Architectural Review  
and Historic Preservation Board  
Agenda Report

File: AR 17-41

RE: Aguilar Duplex Apartments, 917 West Sacramento Avenue; APN 043-210-045

**SITE PLAN** 1" = 20'-0"

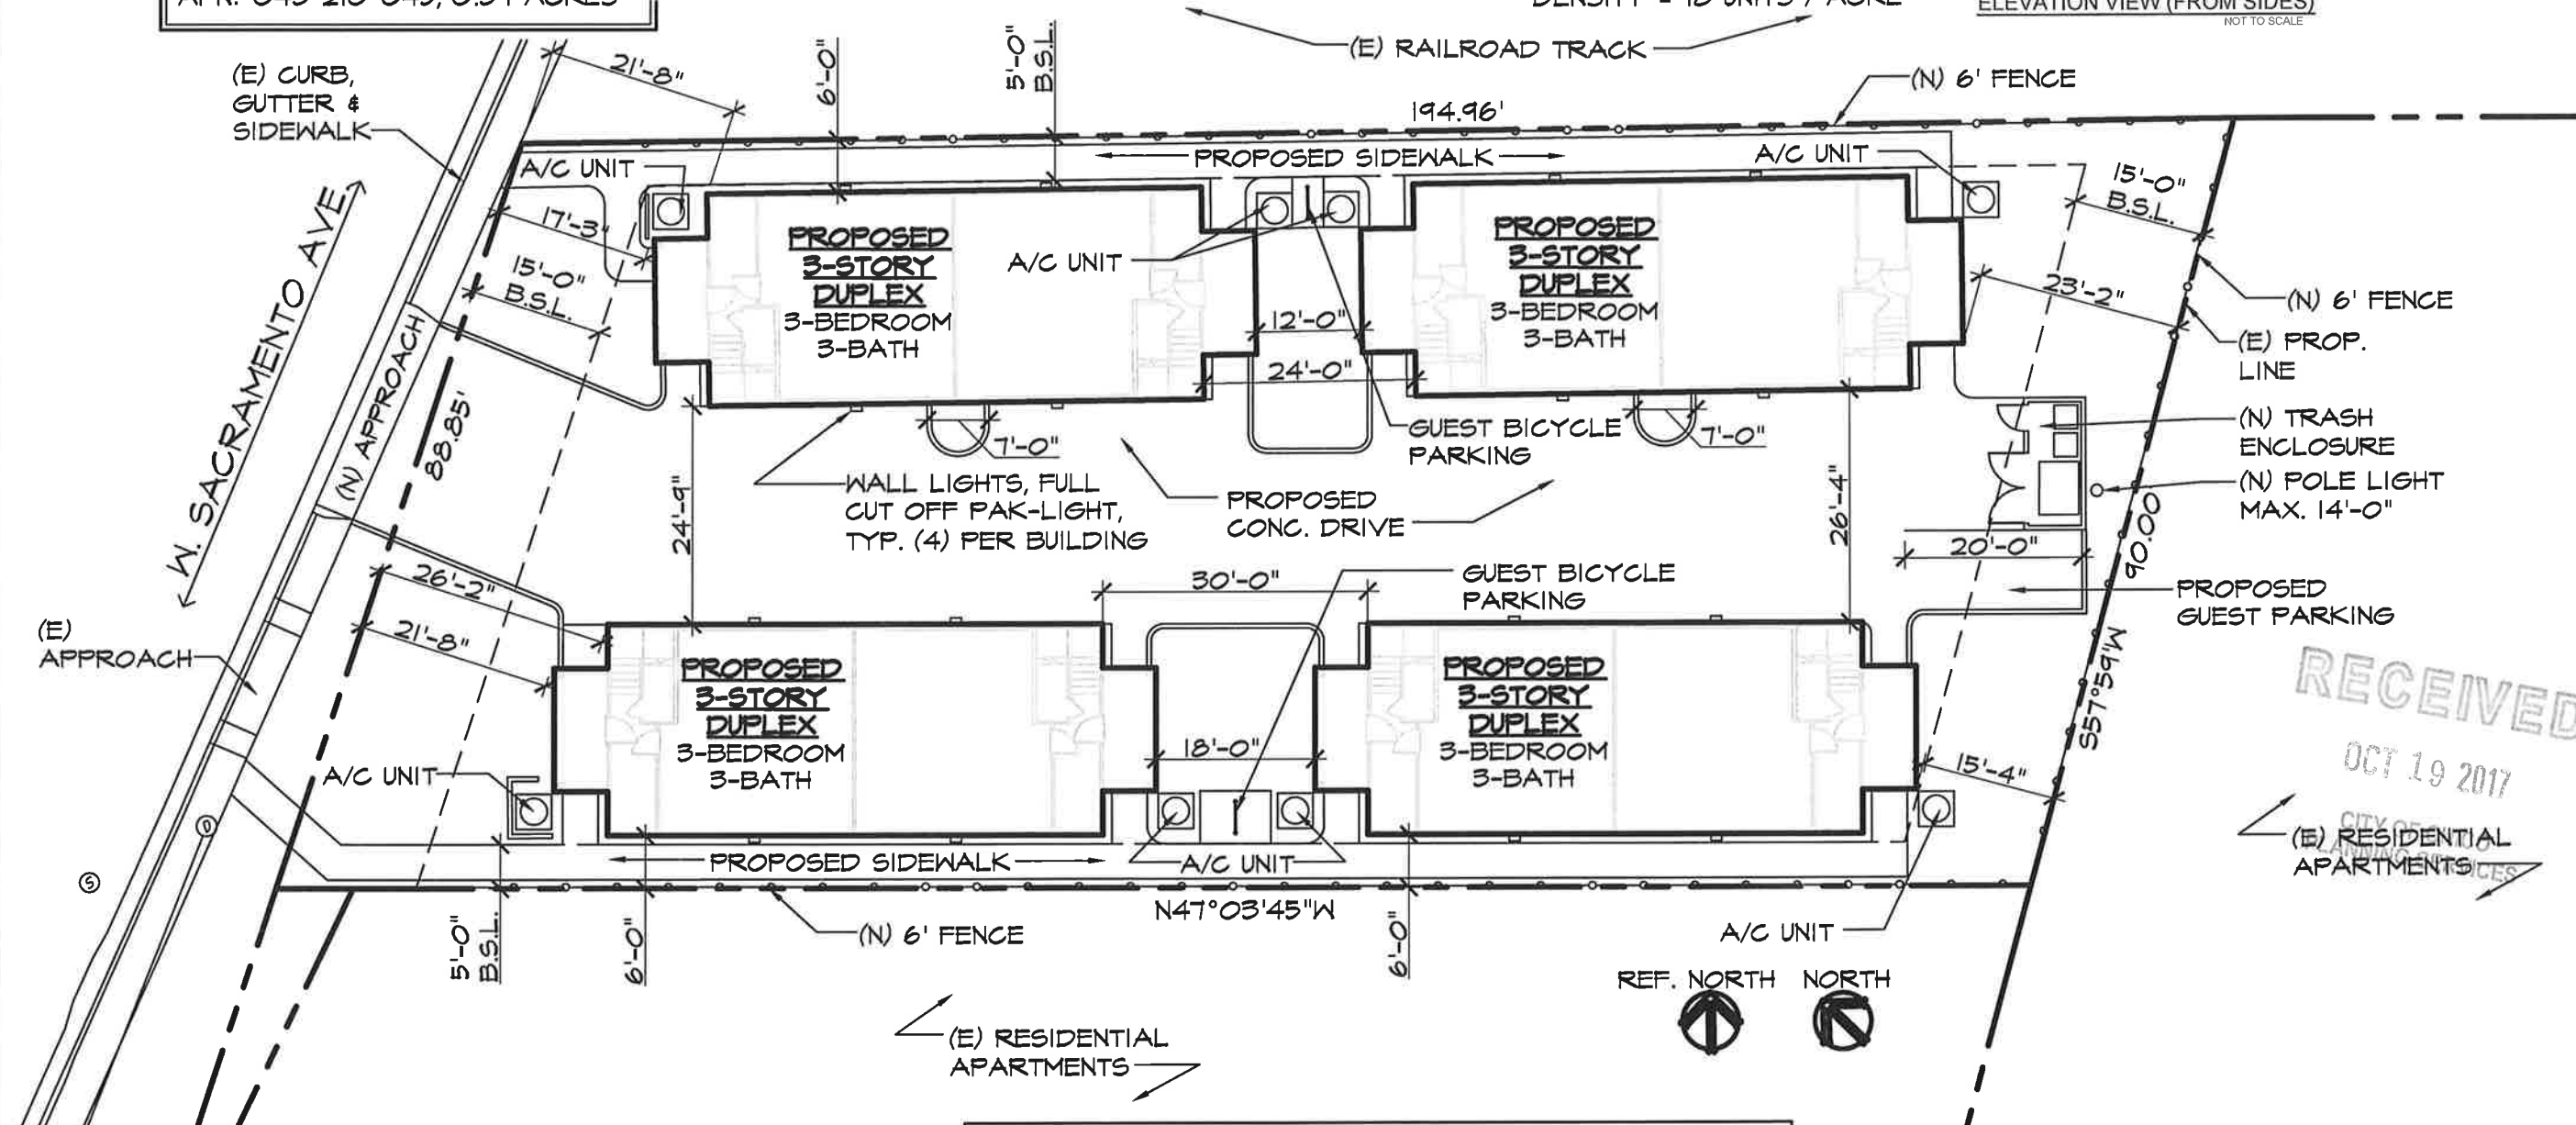
The proposal includes four new three-story duplexes with tuck-under parking, parking lot shade trees, trash enclosure and surrounding landscaping. The site is currently vacant. The proposed site plan illustrates the buildings oriented to the northeasterly and southwesterly property lines with a 24-foot drive aisle down the middle. The buildings located towards the front of the site are set back 15 and 21 feet from the front property line (see **Attachment B**, Overall Site Plan and **Attachment C**, Project Description).

Each unit includes a two-car garage with a bicycle storage closet inside. A single guest parking space is provided at the rear of the site and four guest bicycle parking spaces are provided at the center of the site. All parking requirements have been satisfied pursuant to CMC 19.70. A concrete masonry trash enclosure with ribbed metal doors is proposed at the rear of the site. The enclosure would be textured and painted to match the building color (see Overall Site Plan).

Overall, the proposal efficiently utilizes the site by arranging the building in a vertical fashion, placing required parking inside ground-level garages and living spaces above. The project meets all development standards regarding setbacks, landscaping, parking and open space. Retaining the mature valley oak tree preserves the character of the site and the neighborhood.

ATTACHMENT 'E'

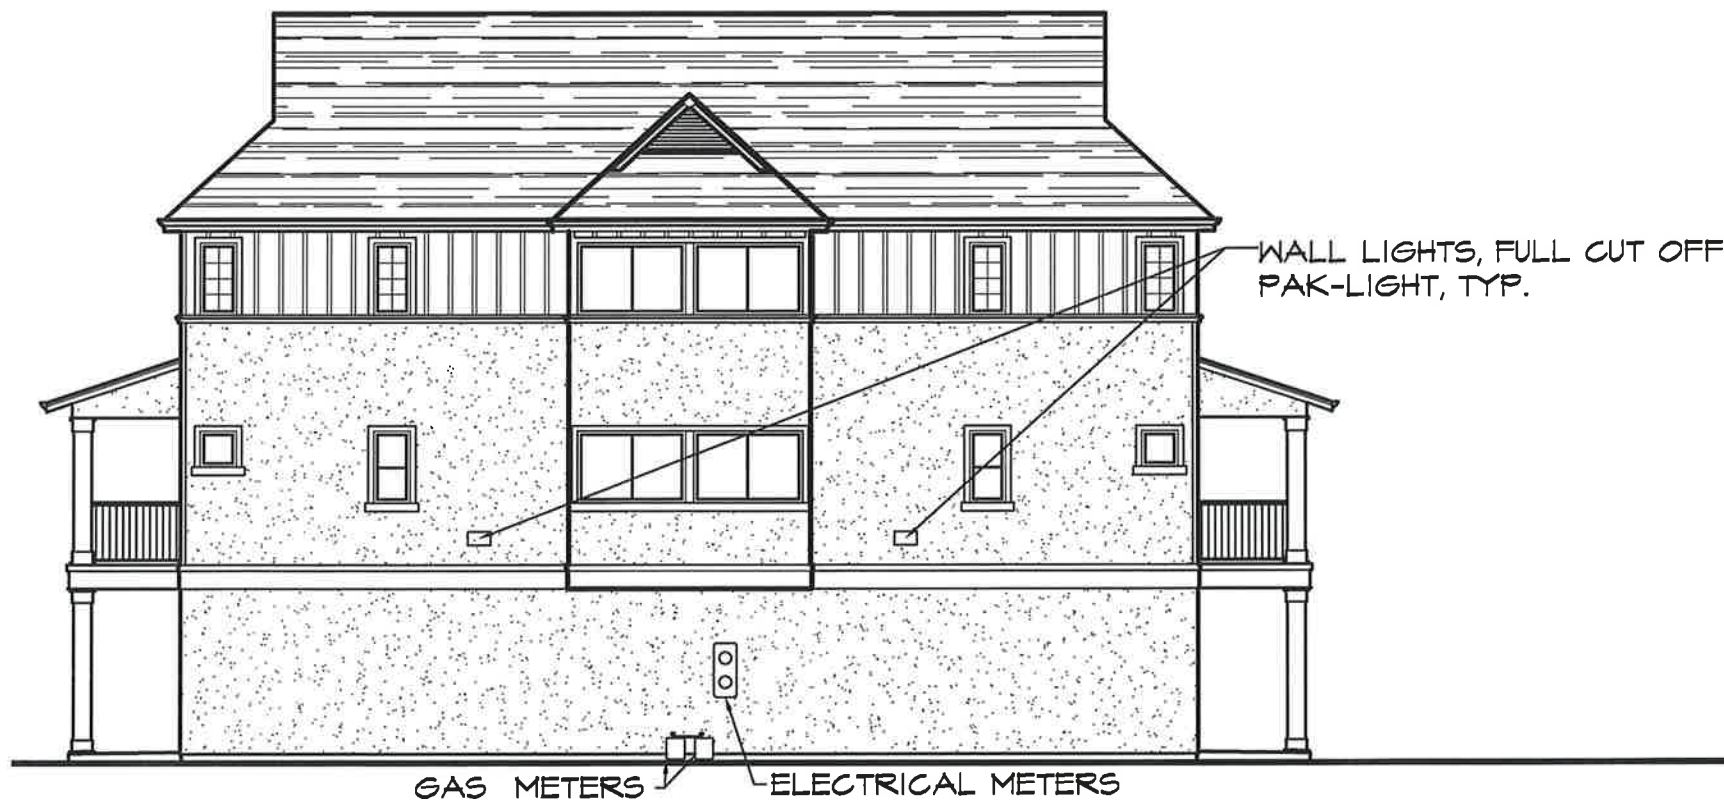
The exterior of the building would feature stucco surfaces with a band of board-and-batten paneling on the third floor. The first story of the structure would be beige (Sherwin Williams "Basket Beige") with reddish-brown garage doors (Sherwin Williams "Arresting Auburn"). The second story would be green (Sherwin Williams "Rock Garden") with a band of dark green board-and-batten siding above (Sherwin Williams "Roycroft Bottle Green"). First- and second-story windows and doors would be trimmed in beige and all other building and window trim would be black (Sherwin Williams "Black Magic") (see **Attachment D**, Color Board)

The front a rear elevation of each building would feature a second-story balcony with a gable roof supported by vernacular-style wood columns. The balconies, supported by the same style columns, create covered first floor entry porches below, six feet in depth. The side elevations of each building would feature a slight cantilevered mass. Window types include double-hung, slider and multi-panel. Ground mounted HVAC units would be located on front and rear corners of the buildings, screened from public view by a low fence and vine plantings (see **Attachment E**, Elevations). Wall pack lights are proposed over each garage door, on the buildings easterly and westerly elevations, and a single 14-foot pole-light is proposed at the rear of the site (see **Attachment F**, Lighting Specifications). A new six-foot tall fence is proposed around the perimeter of the site. Access to the public right of way is provided by corridors along the backs of the building with long, narrow walkways that span the length of site. These corridors also feature wall mounted gas and electric meters.

3. All wall-mounted utilities and roof or wall penetrations, including vent stacks, utility boxes, exhaust vents, gas meters and similar equipment, shall be screened by appropriate materials and colors. Adequate screening shall be verified by planning staff prior to issuance of a certificate of occupancy.

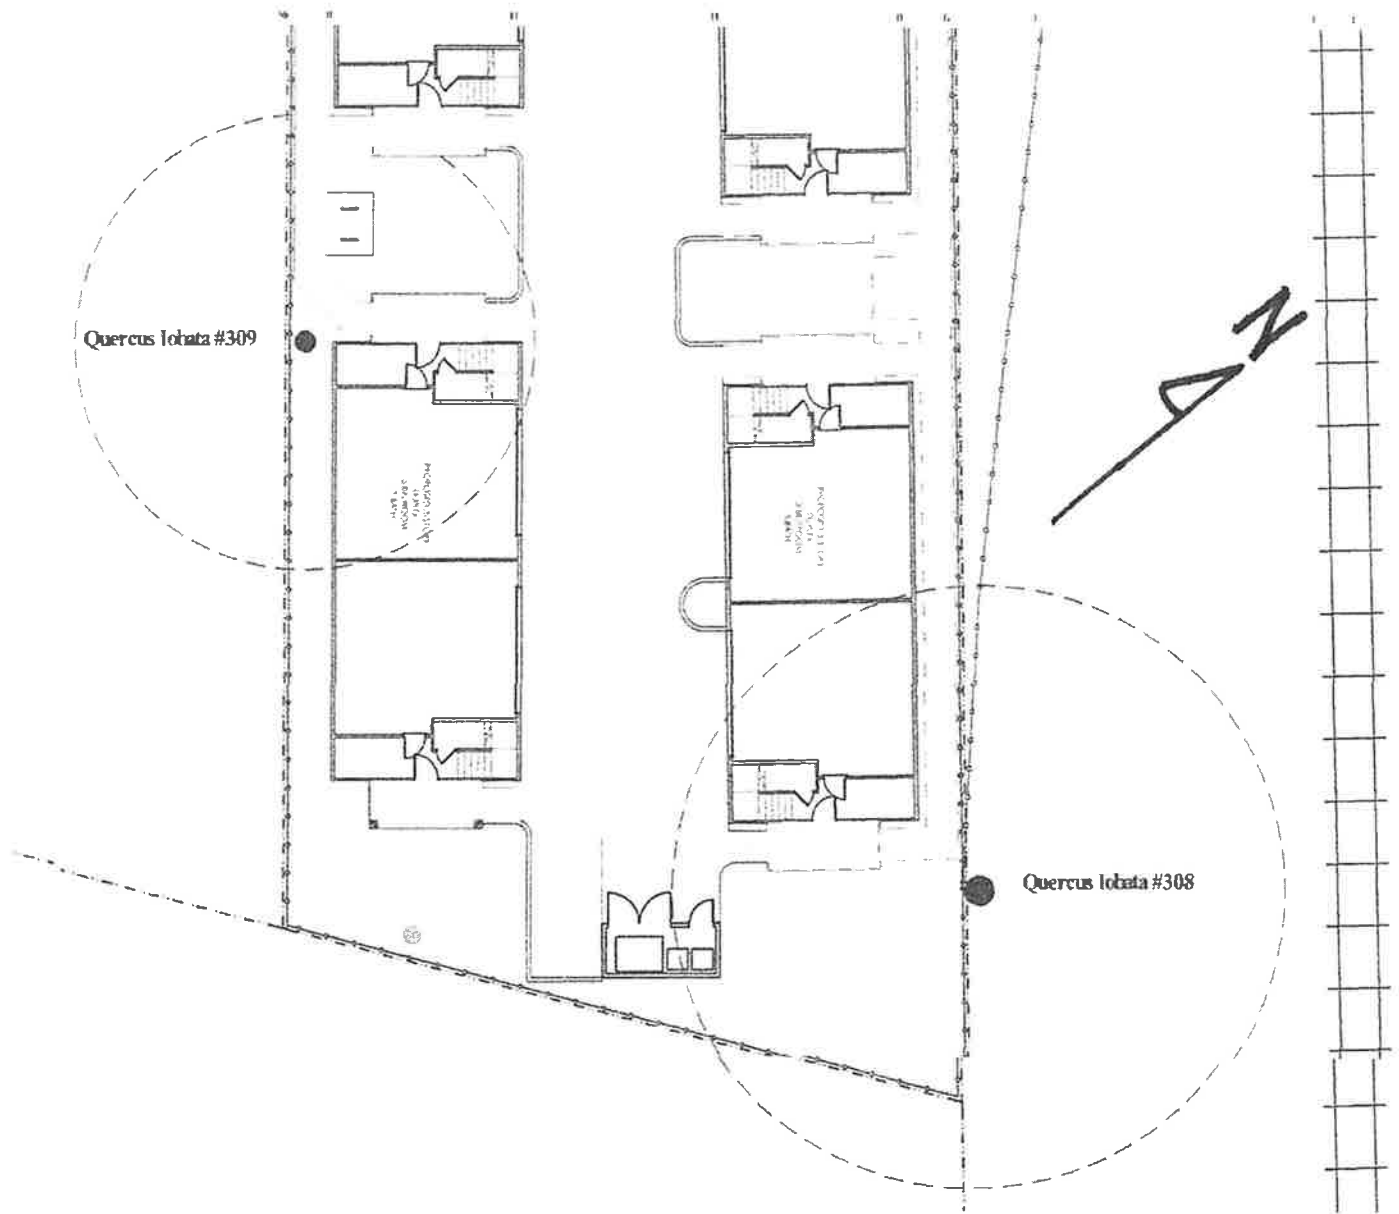
As the diagram on page 7 shows, this tree is in the northeastern corner of the property. I estimate this tree to be more than 100 years old. I determined this from experience and the tree's 45-inch diameter at breast height (DBH). The crown of this tree appeared healthy.

As the diagram on page 7 shows, this tree is in the southwest border mid-way between the front and back of the property. This is a very healthy young oak estimated to be near 35-50 years old.

To fit this project design into the dripline of these trees will require removal of large limbs. The current project design for a 3 -story structure is not recommended without removal of tree #309. Tree removal must be mitigated by planting of oak trees on site and or at locations designated by the city.

A Suitable redesign of the project would limit construction within the dripline of the trees to pruning of limbs no greater than 3 inches in diameter.
